# Apparel Gallery Ltd.

## Structural Inspection Report

Observations & Actions

Category Amber

## Building 1 – Load Reductions Required

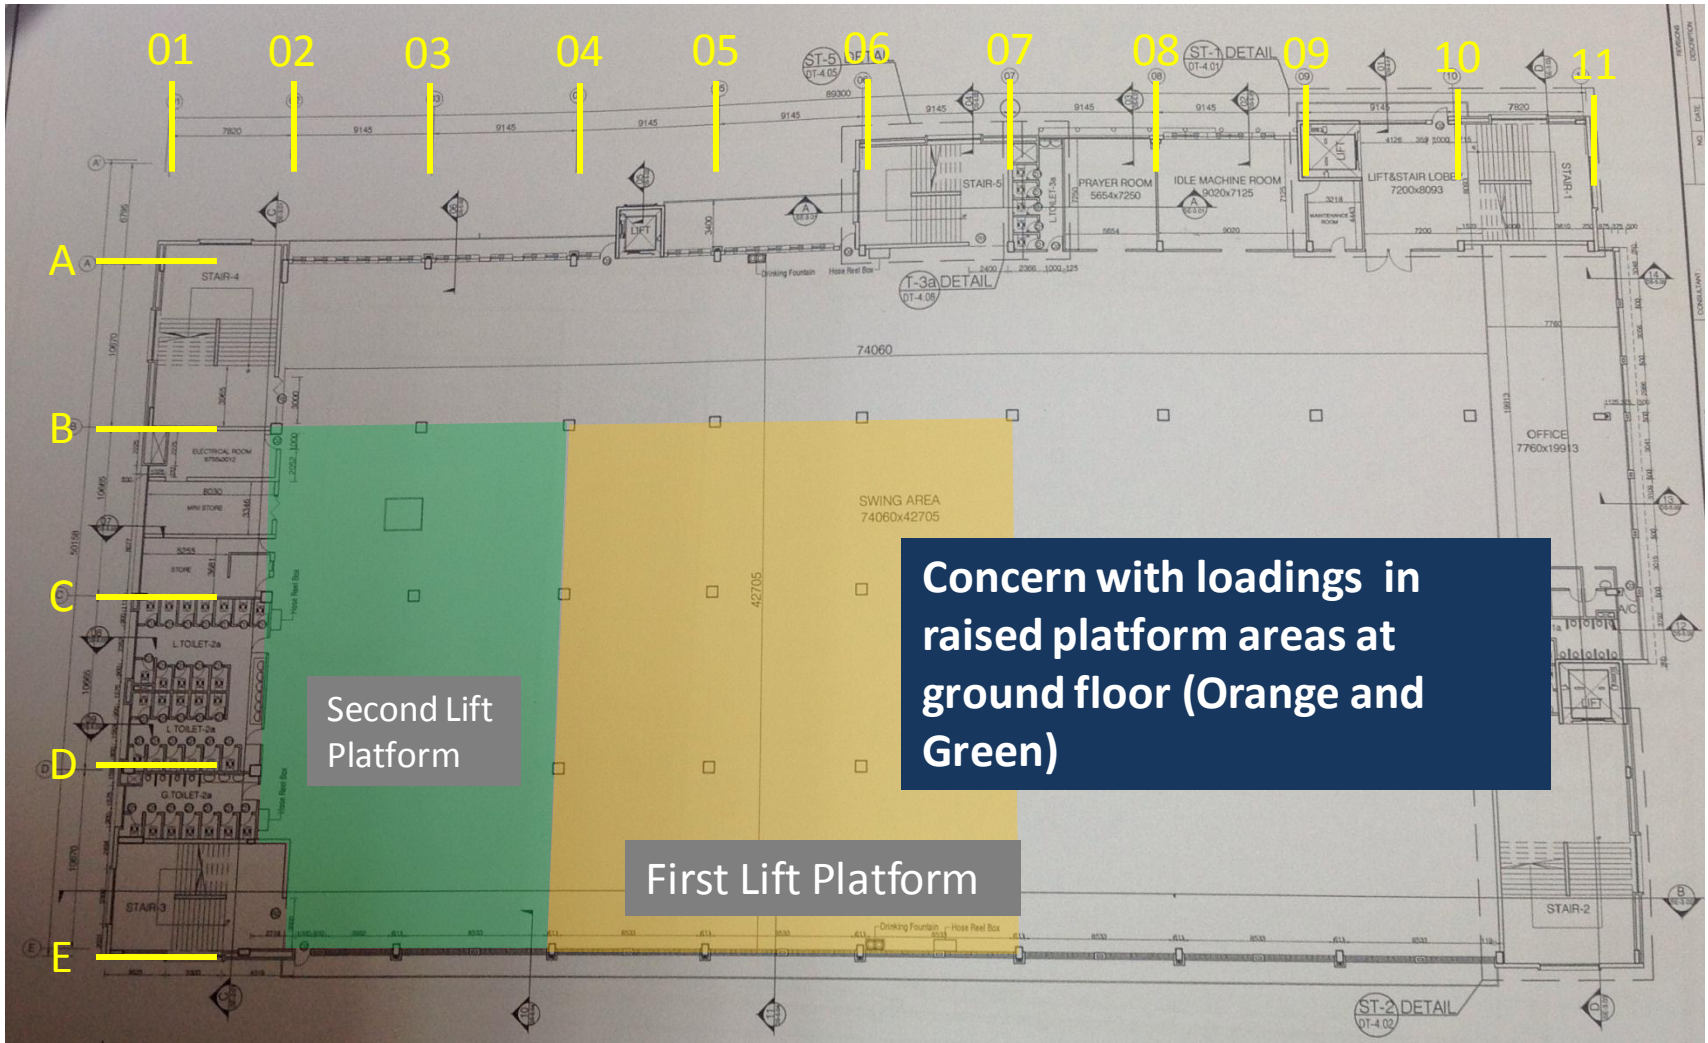
We do have some important concerns that need to be addressed immediately, which give rise to our recommendation for an immediate **reduction loading in areas specified and the investigation of ground floor build-up all as shown on pages 4,5 and 6** below and the immediate commencement of a **Detail Engineering Assessment** (see actions below).

The principal reasons for our concern is that columns at ground floor appear to be stressed to levels that require **immediate** review.

- A full **Detailed Engineering Assessment** is to be commenced for columns in the area of the raised platform at ground floor (Grid B2 to E7 noting the further build up between B2 and E4).
- Until DEA is complete reduce load at all levels to less than 1.5kN/m<sup>2</sup> and especially from stacked garments from area highlighted on page 5
- At ground floor (grid B2-D4) remove the second lift of raised platform and investigate the construction of the lower platform. If found to be solid or filled with sand, remove material or evacuate areas above until structure and foundations proven.
- Conduct concrete tests to prove concrete strength.
- DEA to prove adequacy of foundations in the area B2 to E7 noting the cracking to basement slab at column D3. DEA to confirm if movement is still live as it was noted that the soffit of the ground floor slab had been freshly painted.

## Building 1 – Investigation and possible removal of raised platforms at ground Level

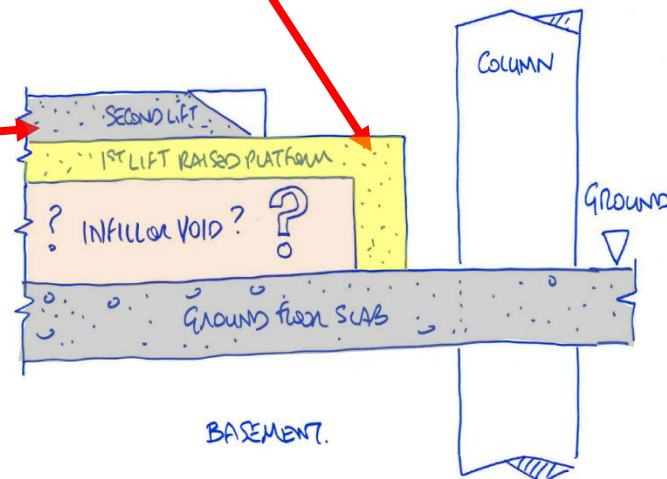
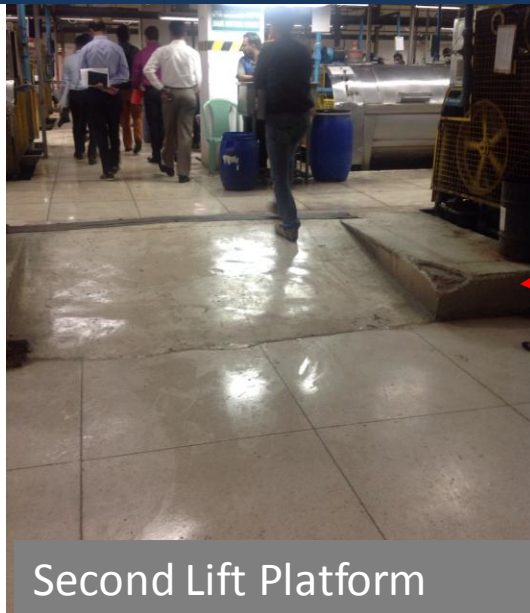
Factory Engineer to open up sections of raised platforms at ground floor level to investigate build-ups, if infill areas are solid we would expect immediate platform removal or local evacuation in these areas until structure and foundation capacity is proven.

**Heavy loading due to raised floor area on Ground Floor**

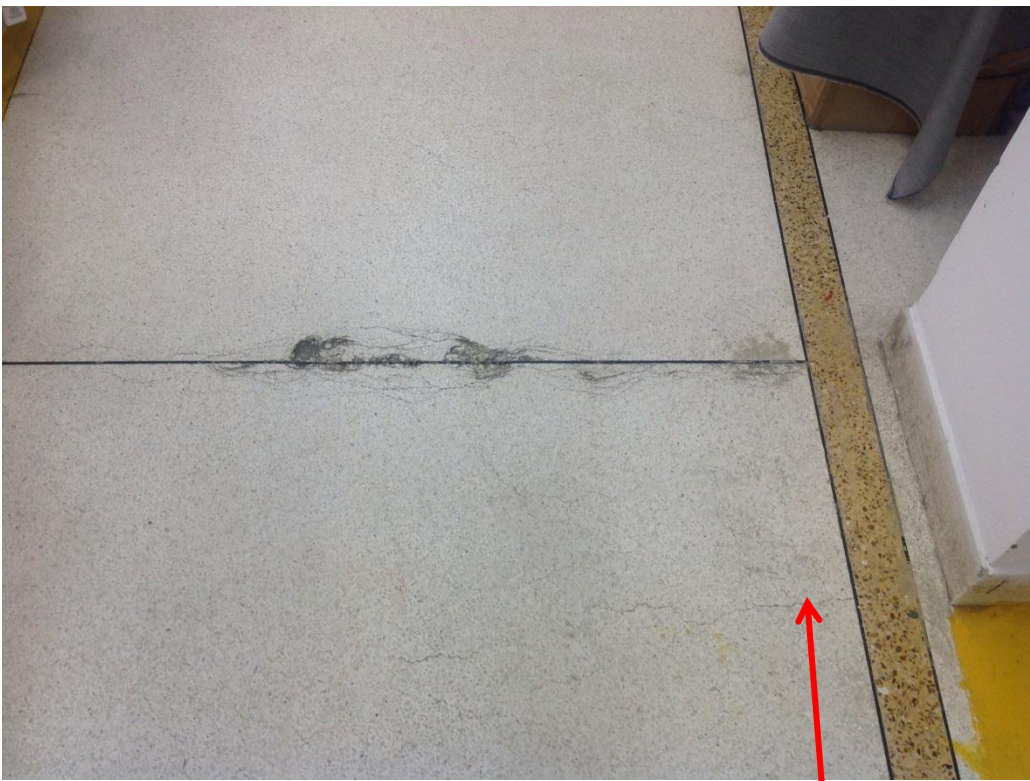
Raised floor area on top of raise area, not identified on drawings. Build up unknown.

**Repaired cracking in soffit of  
ground floor slab.**

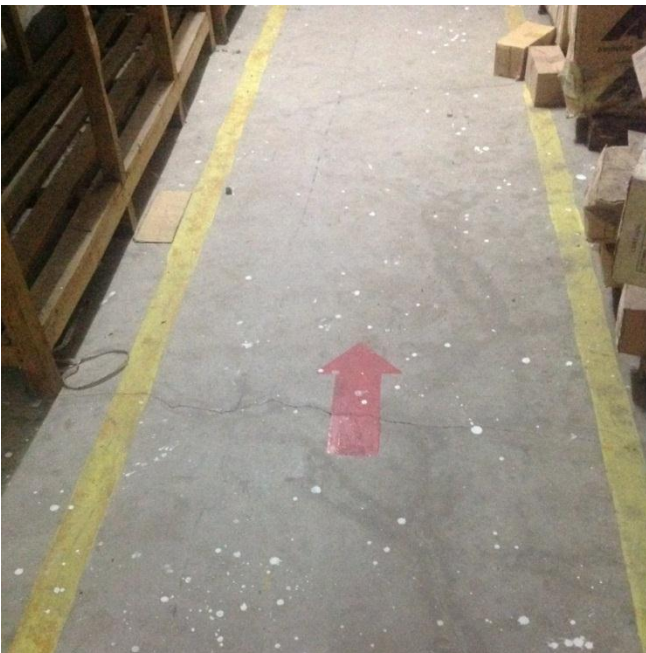
Recently repaired  
cracking in Soffit of  
ground floor slab  
adjacent to column  
with Basement  
slab cracking.

- Evidence of repairs to cracks in soffit of ground floor under raised floor area's, repair should be removed by Building Engineer and reinforcement behind check for possible signs of corrosion.

## Timber roof

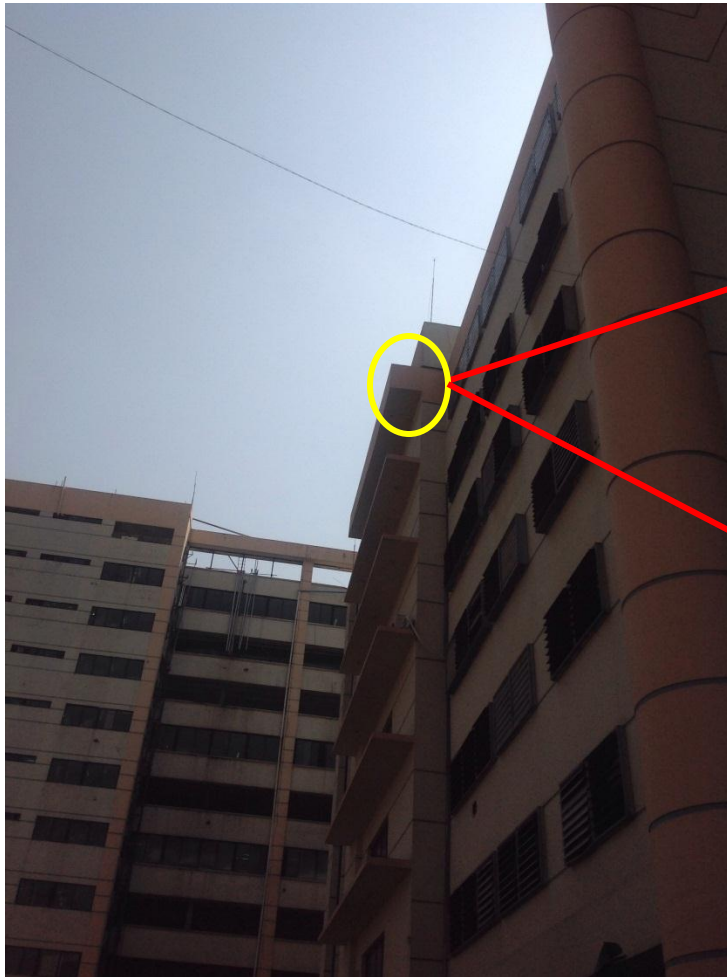
Lightweight timber roof on steel beam cut at one end

Connection to be checked.

- Building Engineer to inspect section of roof that remains and verify its adequacy against uplift giving consideration to open door on roof.

## Water Storage

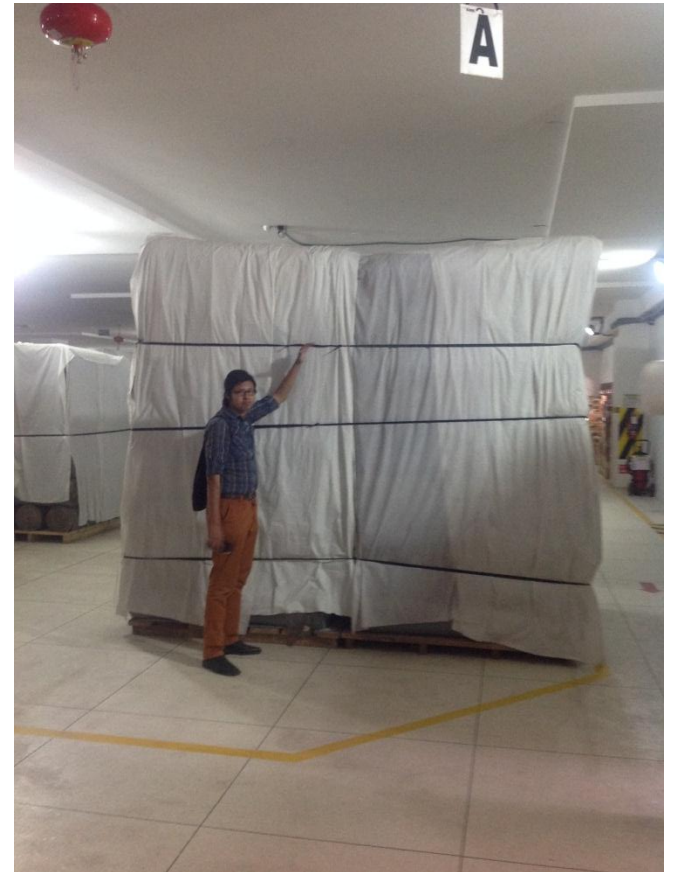
6 No. 2500L water tanks. (Currently not connected or filled)

## Floor Cracking

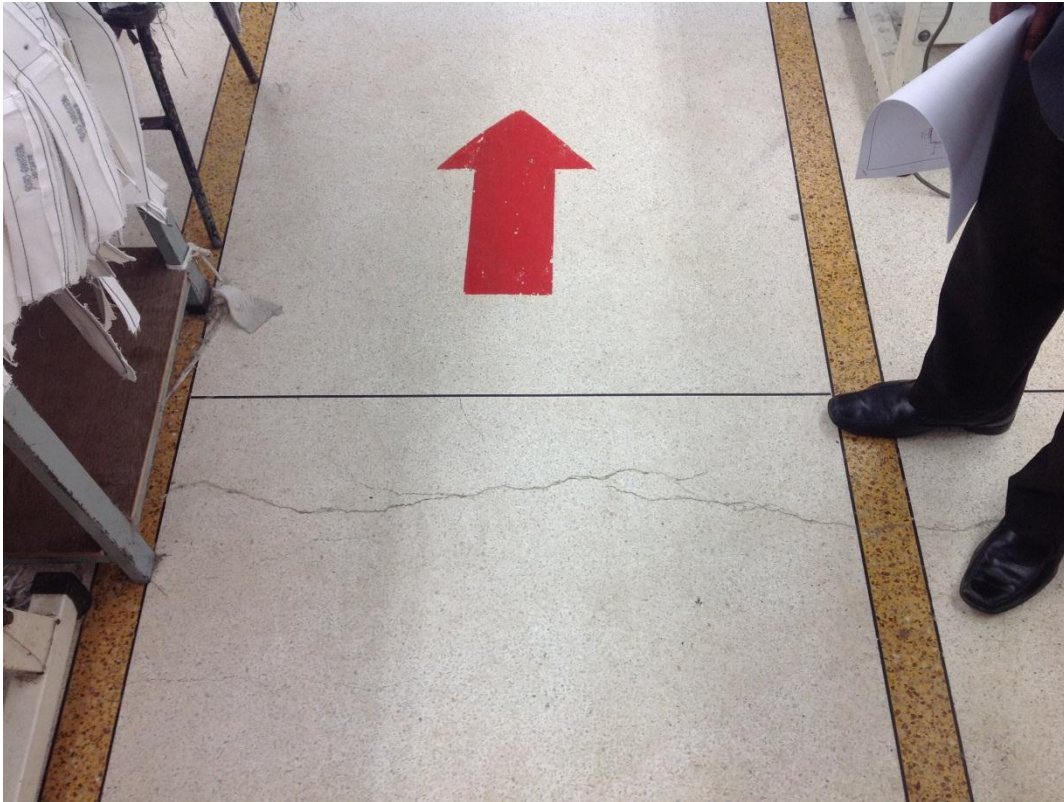
Cracking on  
column line.

## Column without vehicle protection

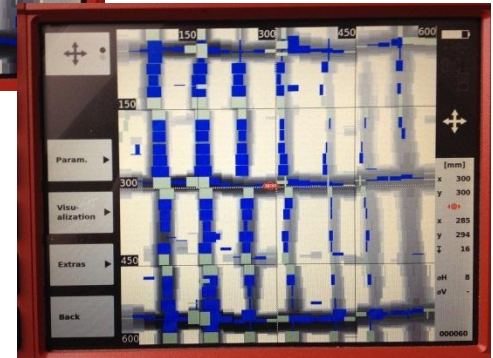
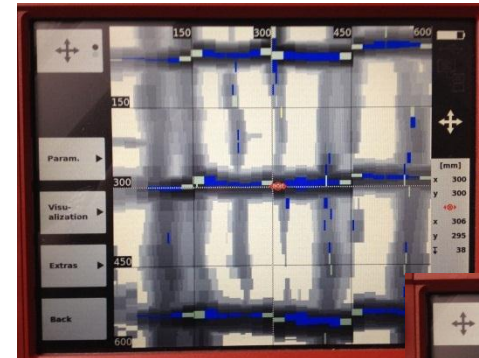
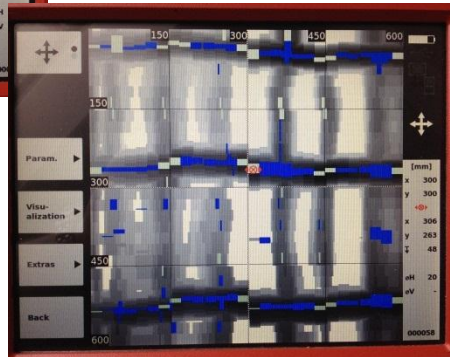
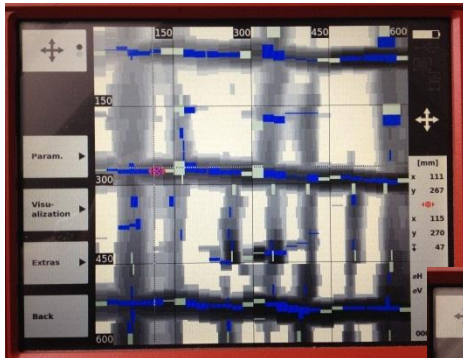
Column in loading bay vulnerable to vehicle impact.

Impact protection should be provided.

- Impact protection should be provided.
